Re: Langston Concrete Inc. M 2020-023
Fremont County, Colorado
Langston Borrow Pit – New 112c Application, Adequacy Review #1

On October 26, 2020 Langston Concrete Inc. received an adequacy review request from the Division. Please see the enclosed information as response to the requested adequacy questions.

EXHIBIT B - Index Map
Langston Borrow Pit M-2020-023
Fremont County, Colorado
Langston Concrete Inc. Florence CO

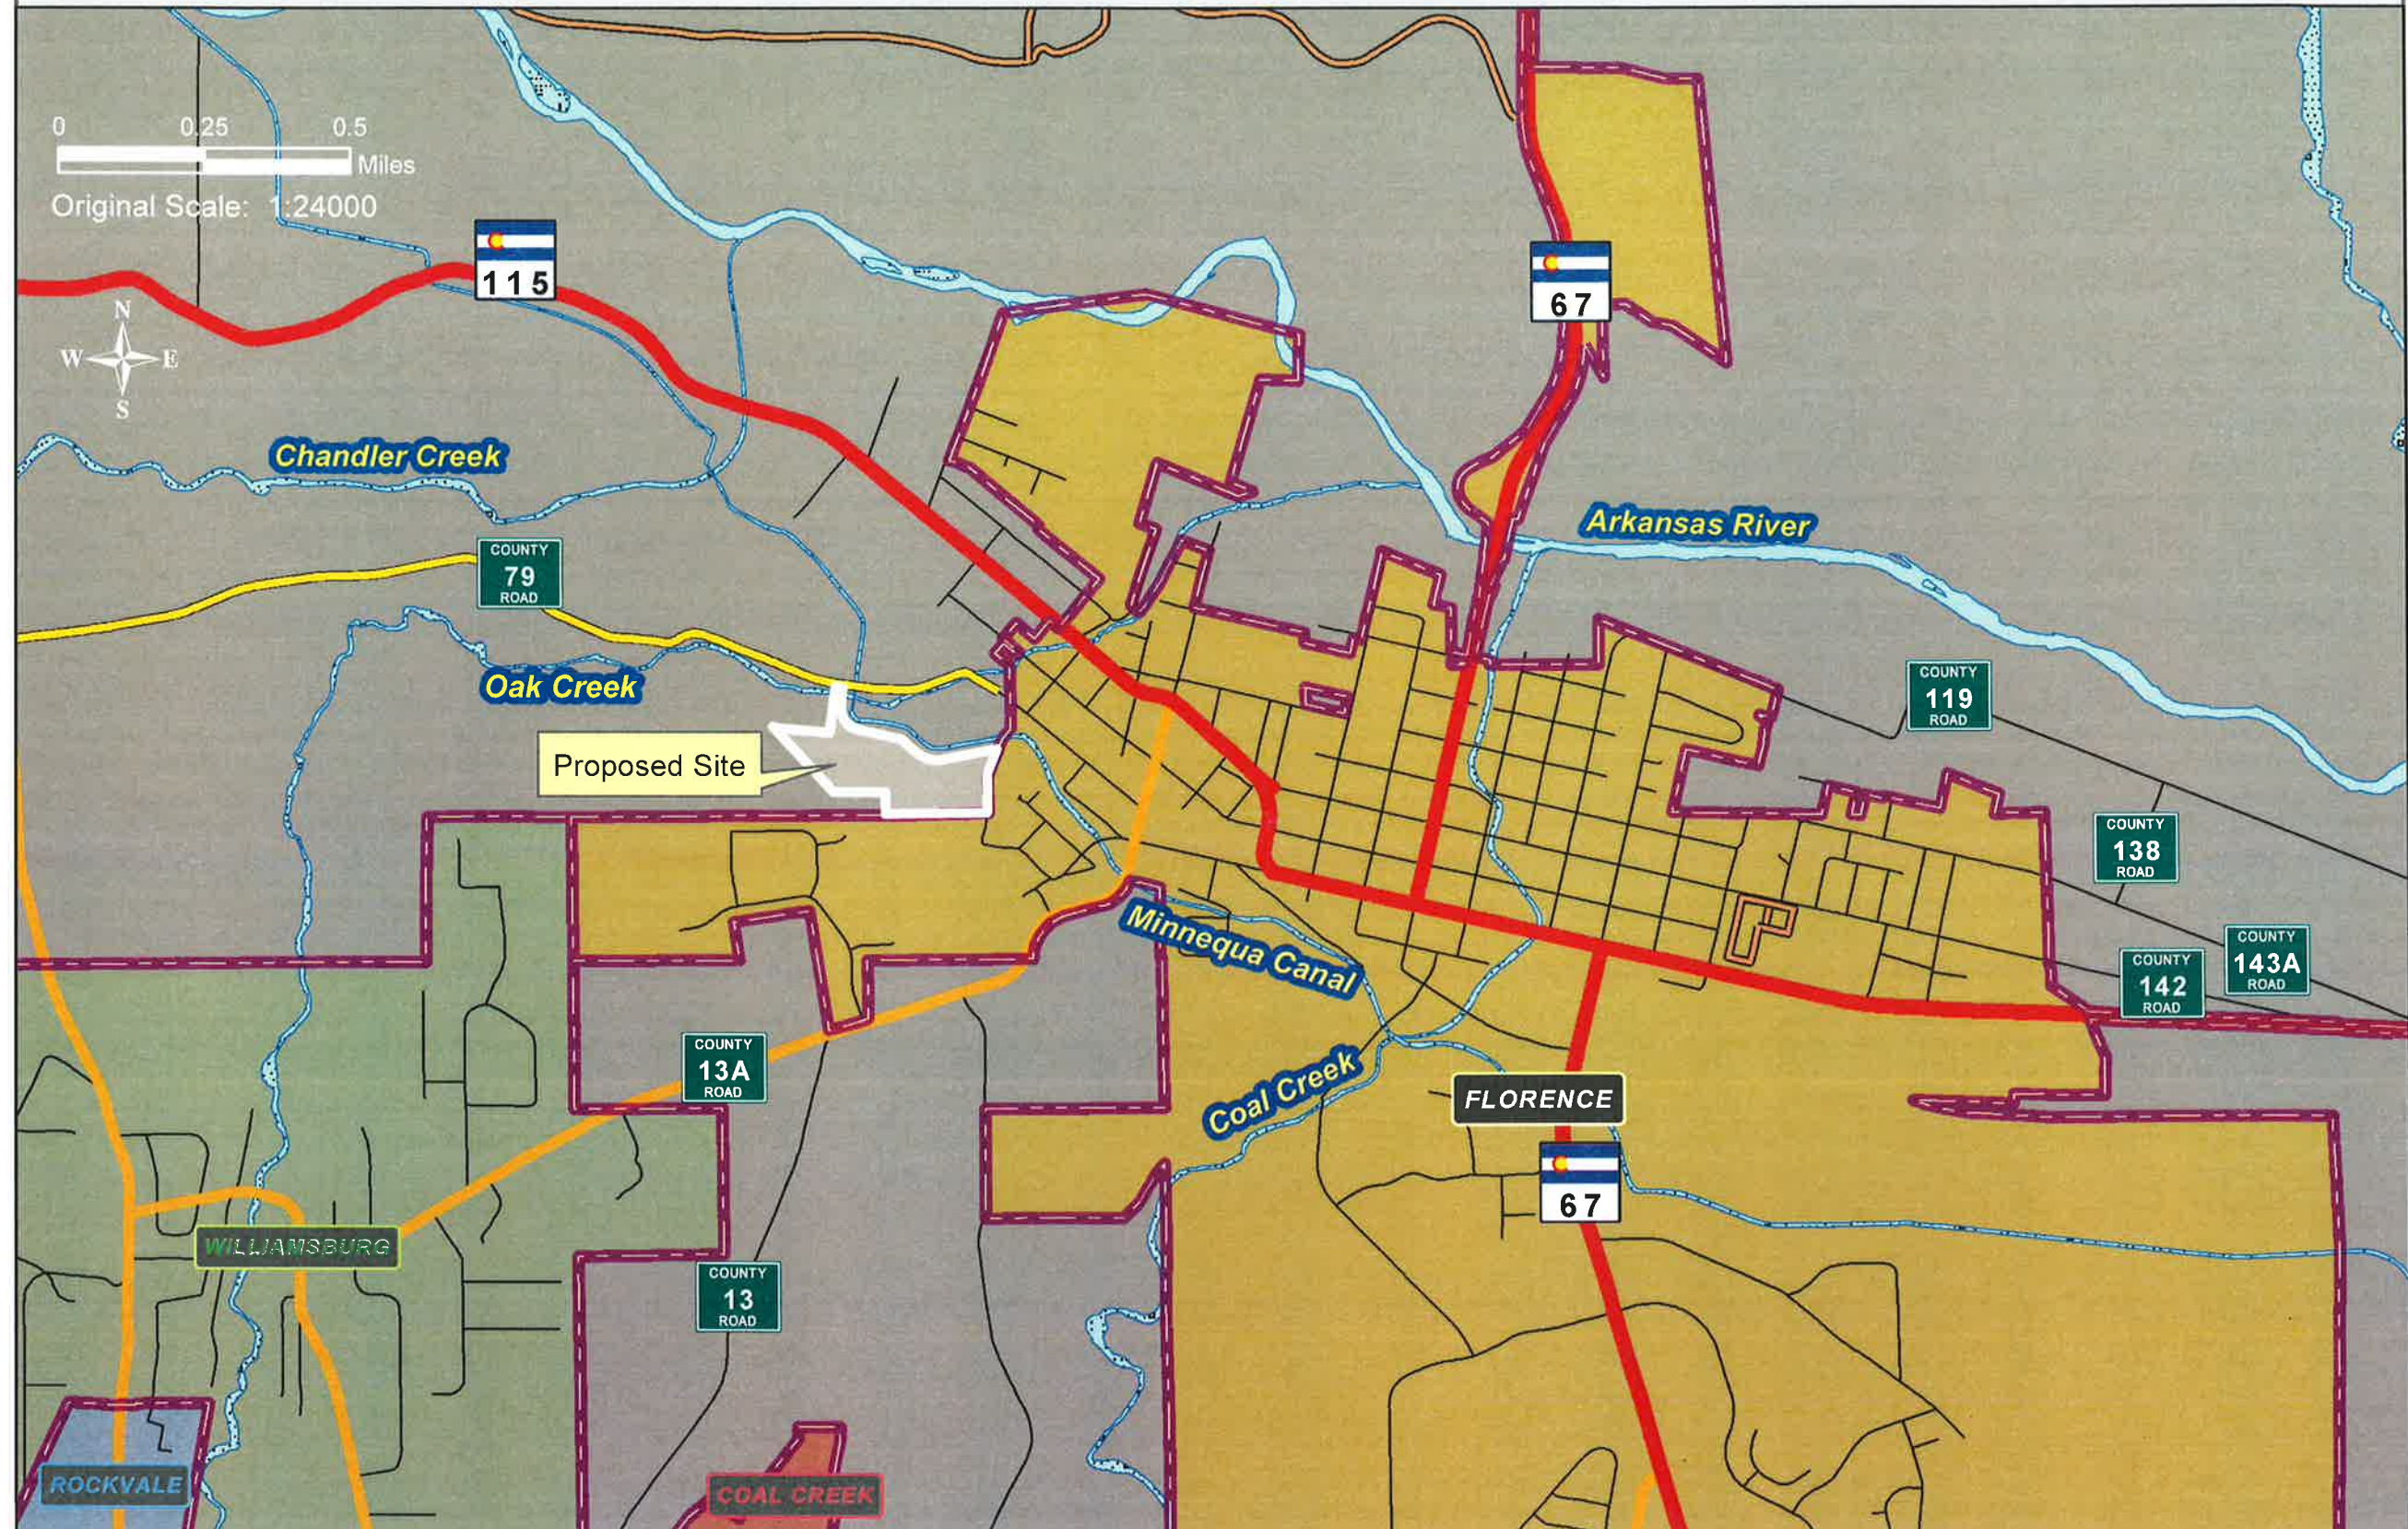
#2 Please see the updated Exhibit B map.

EXHIBIT C - Premining and Mine Plan Map
Langston Borrow Pit M-2020-023
Fremont County, Colorado
Langston Concrete Inc. Florence, CO

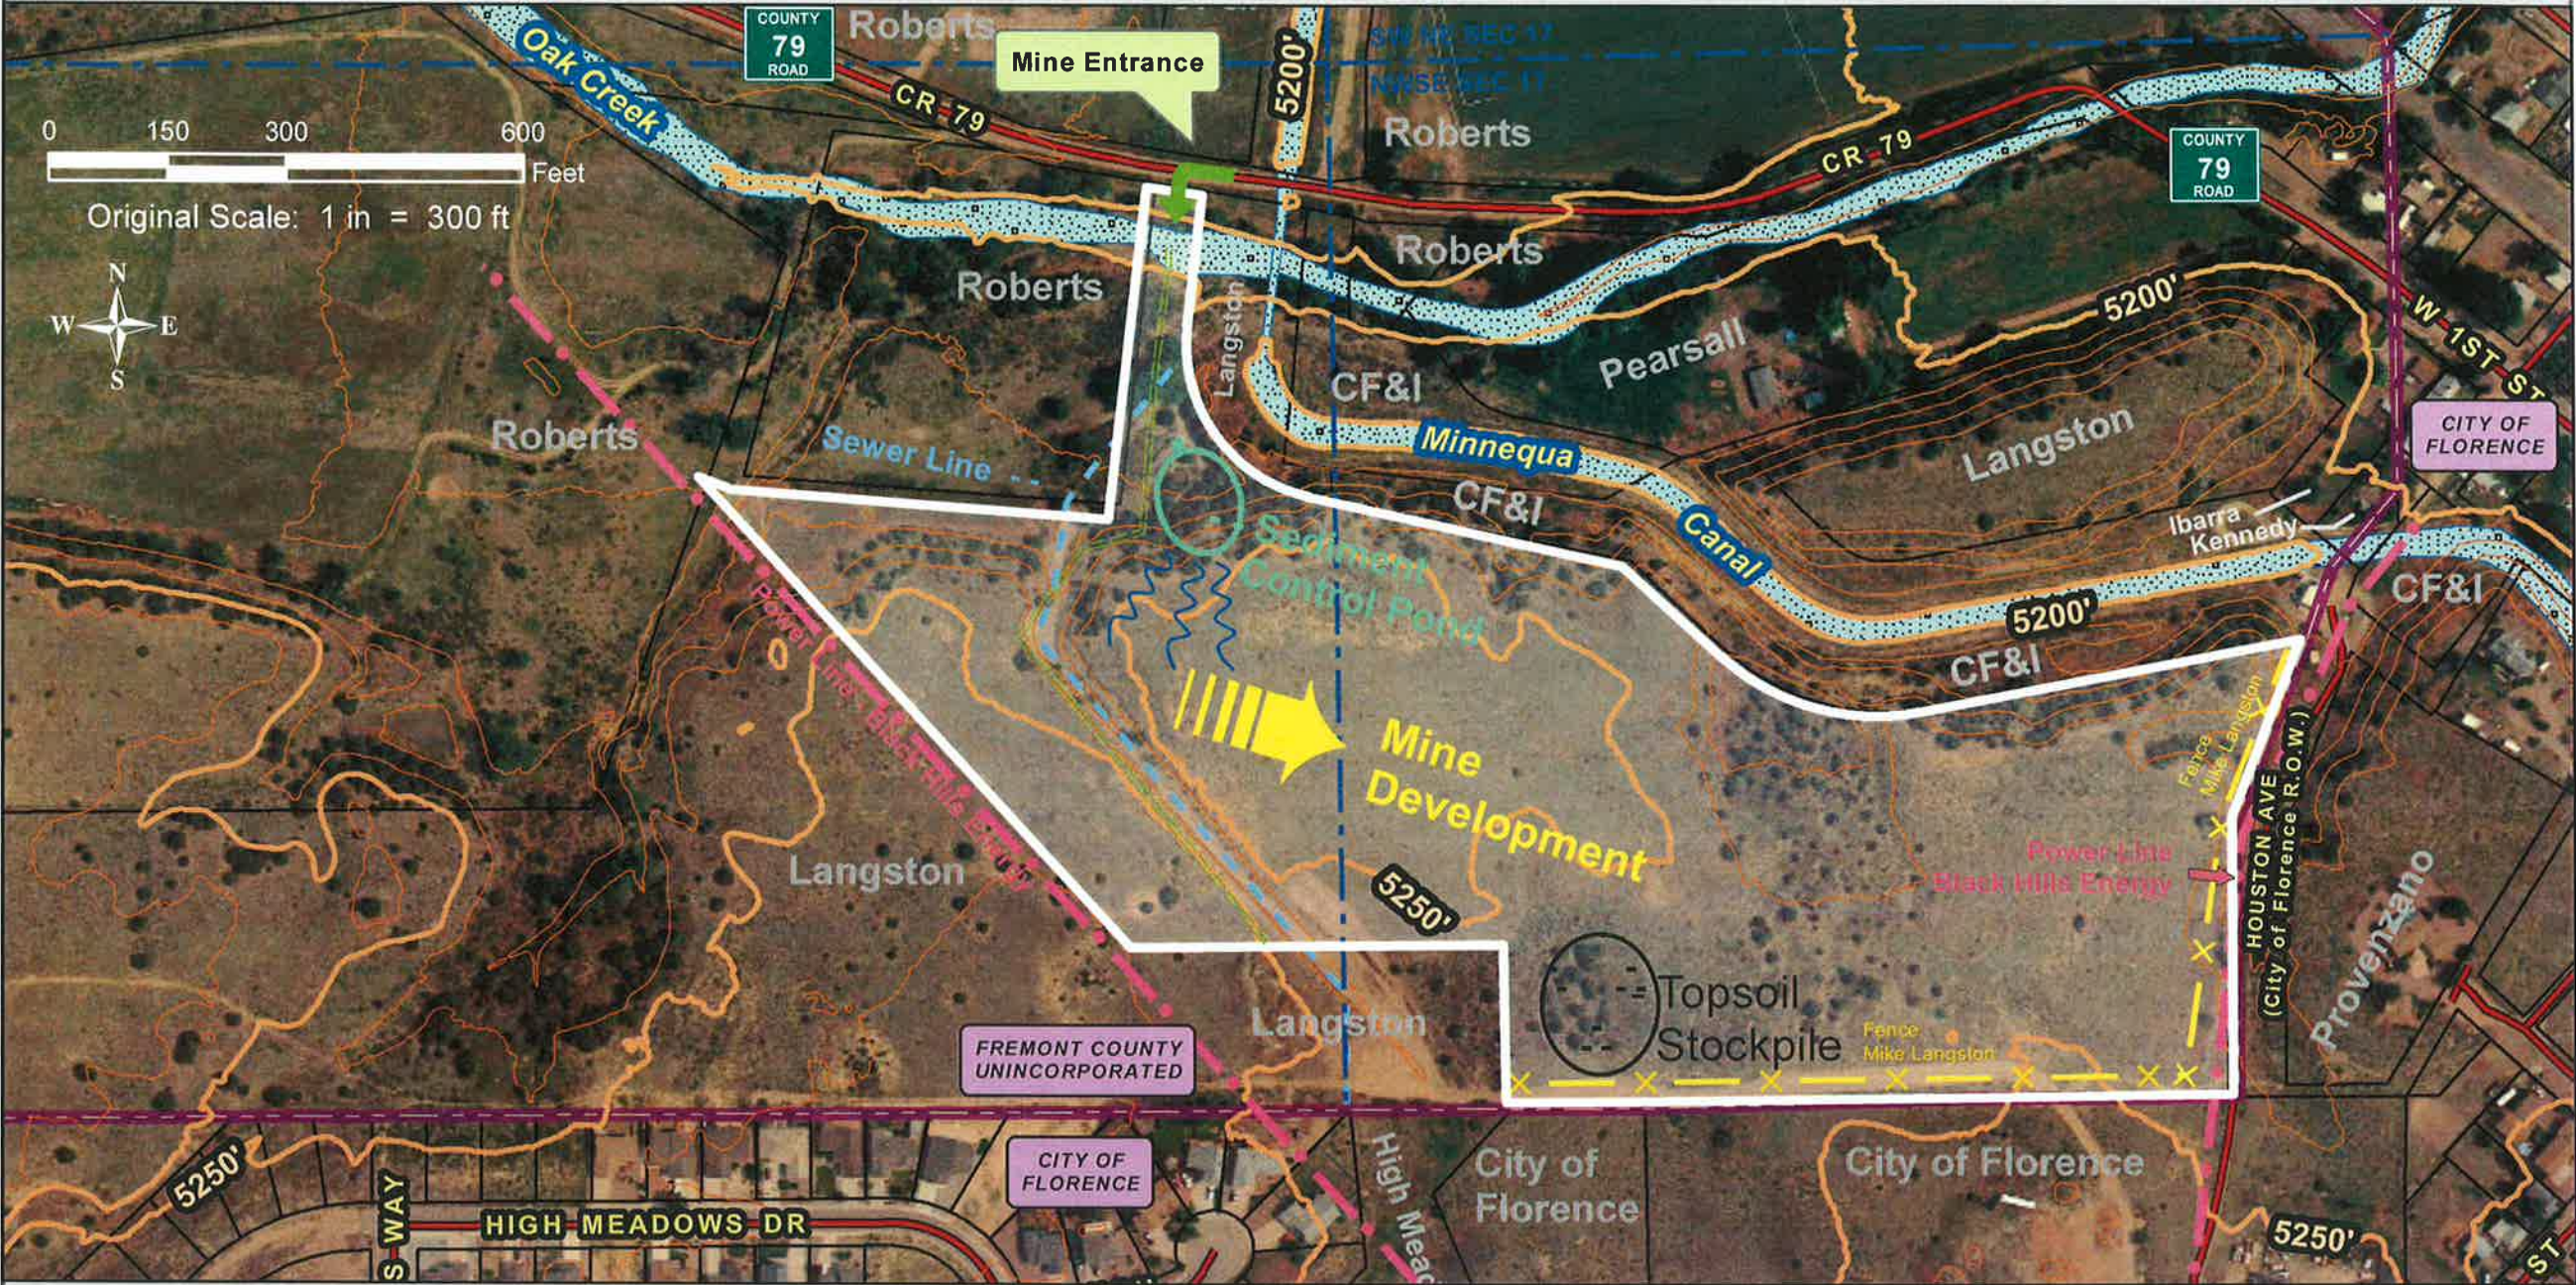
#3 Please see updated map.

#4 Please see updated map. Black Hills Energy owns the powerlines. Please see the attached Structure Agreement.

#5 Please see updated map.

#6 Please see updated map.

#7 Please see updated map.

#8 Yes, there is a fence. The owner of the fence is Mike Langston. Please see the attached Structure Agreement.

EXHIBIT F - Reclamation Plan Map
Langston Borrow Pit M-2020-023
 Langston Concrete Inc. Florence CO

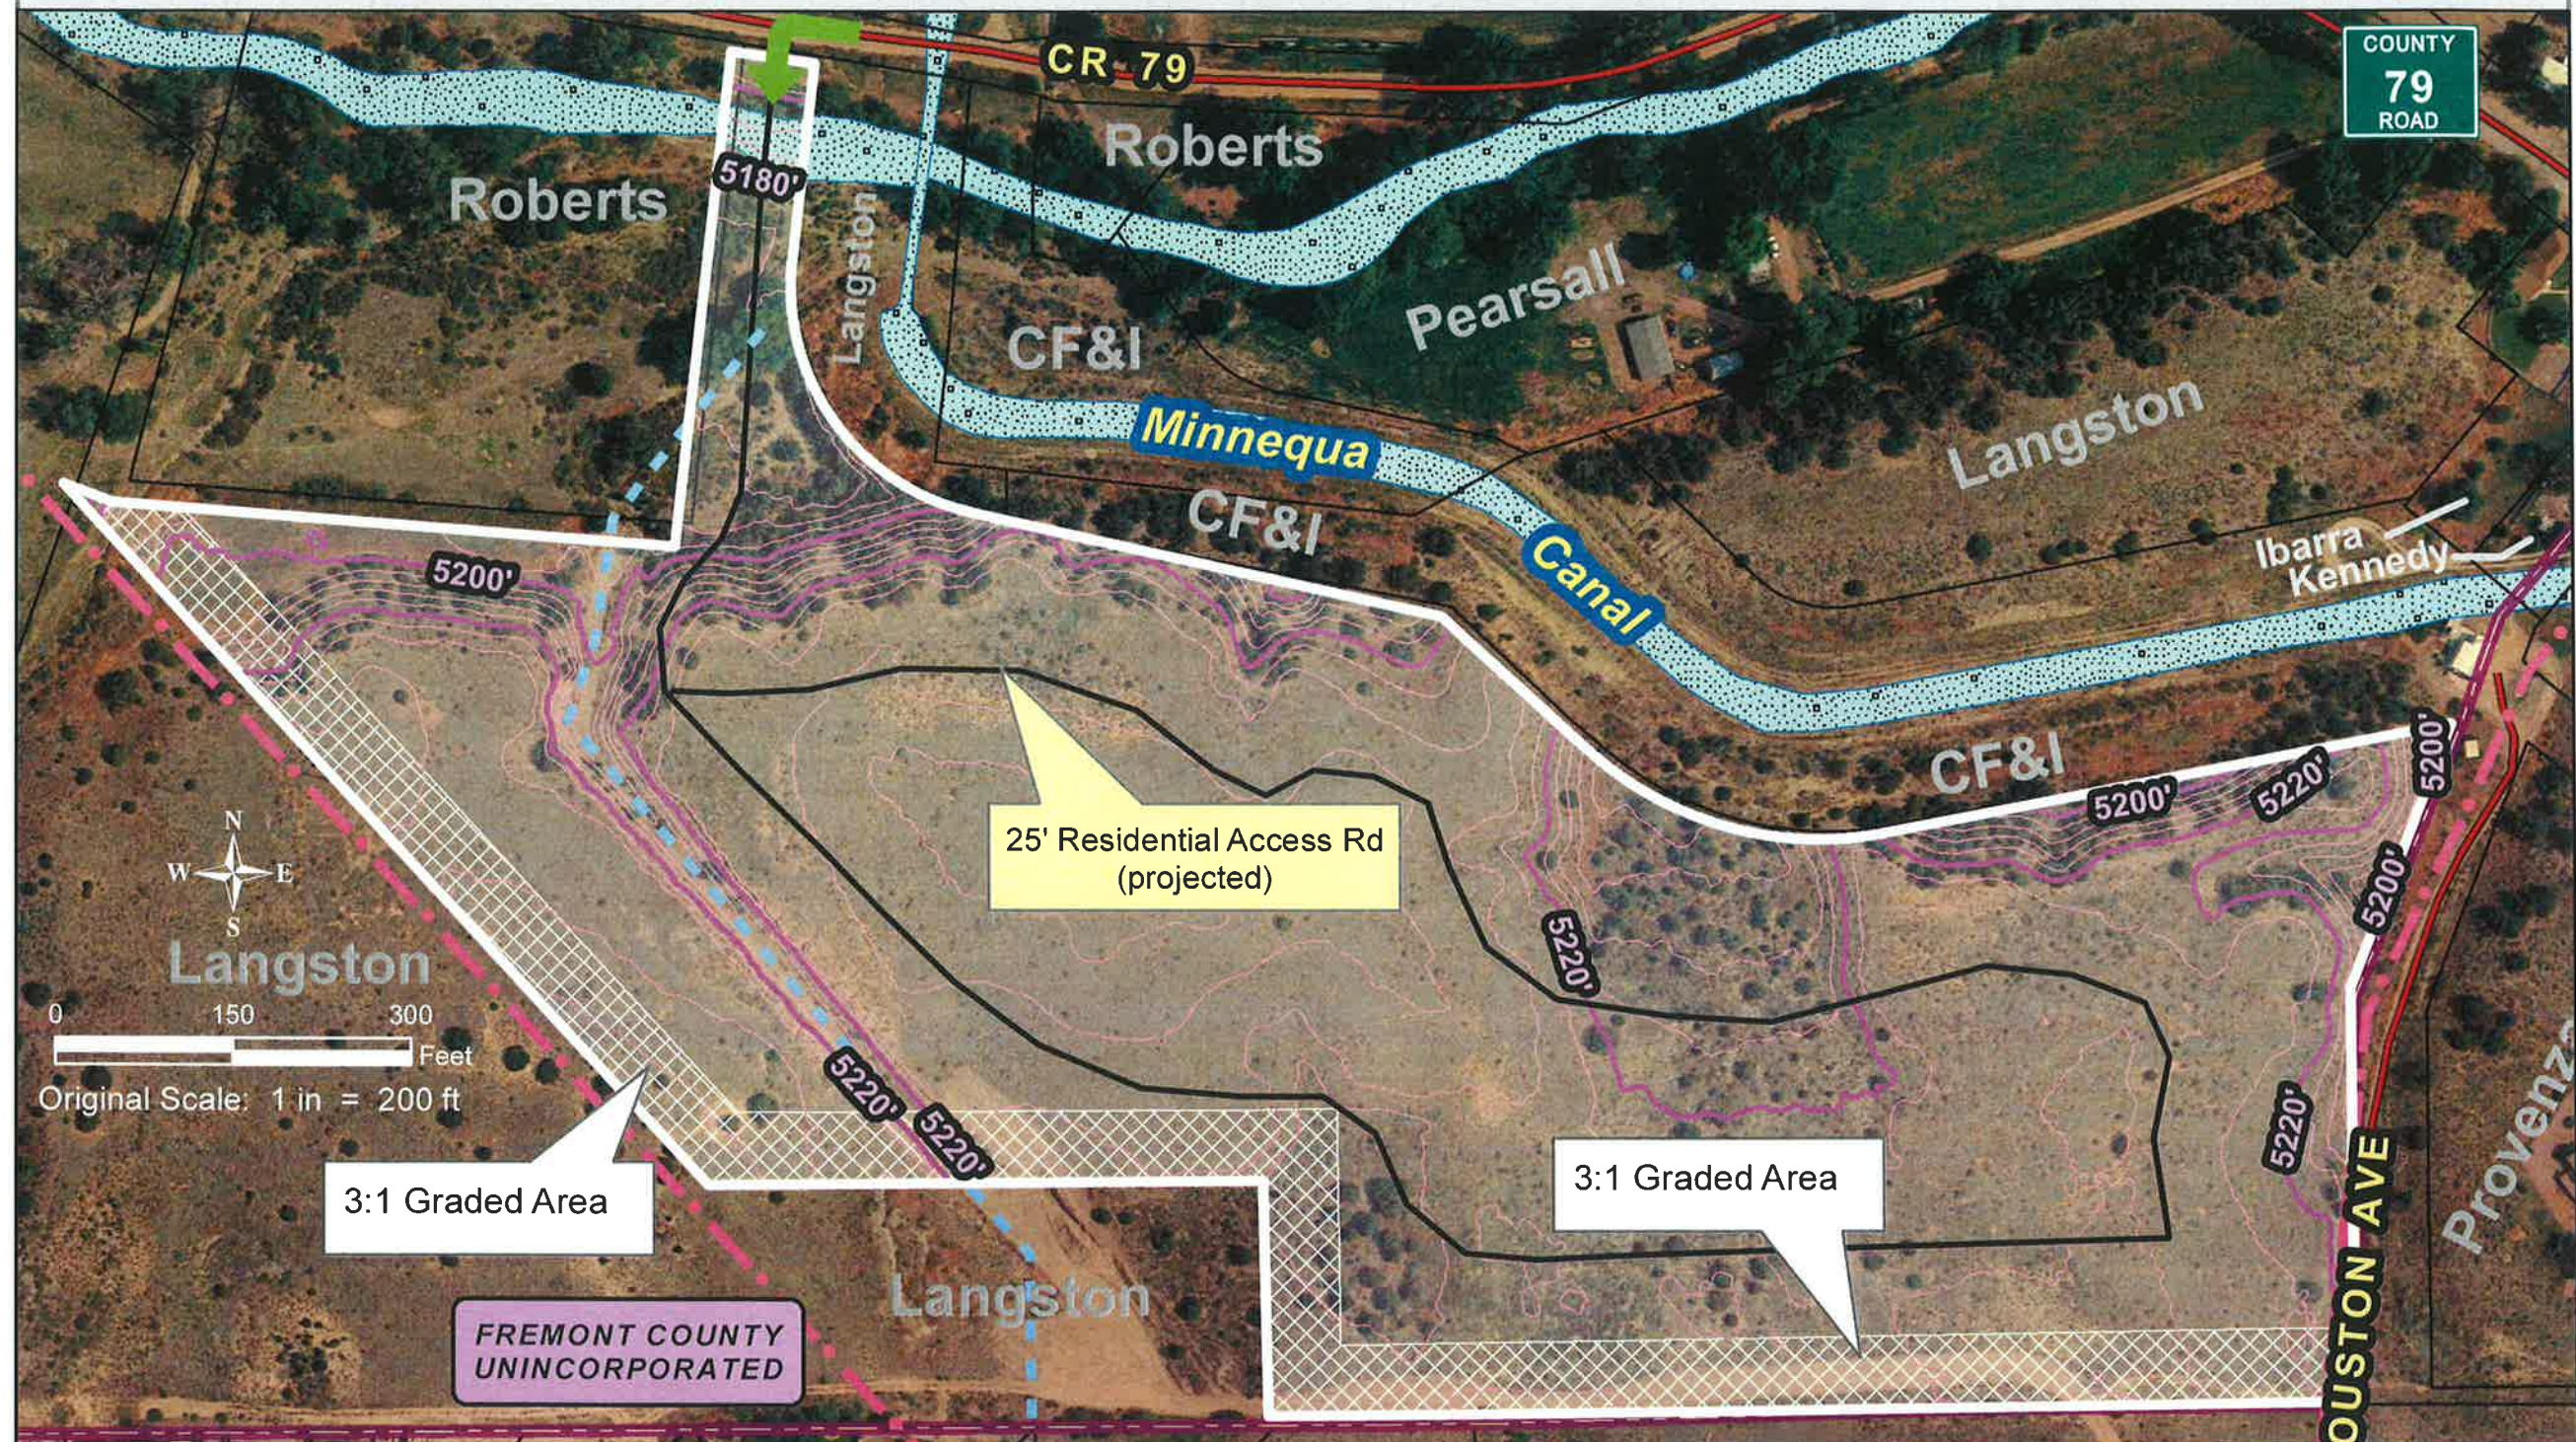
#16) Please see the attached, updated map.
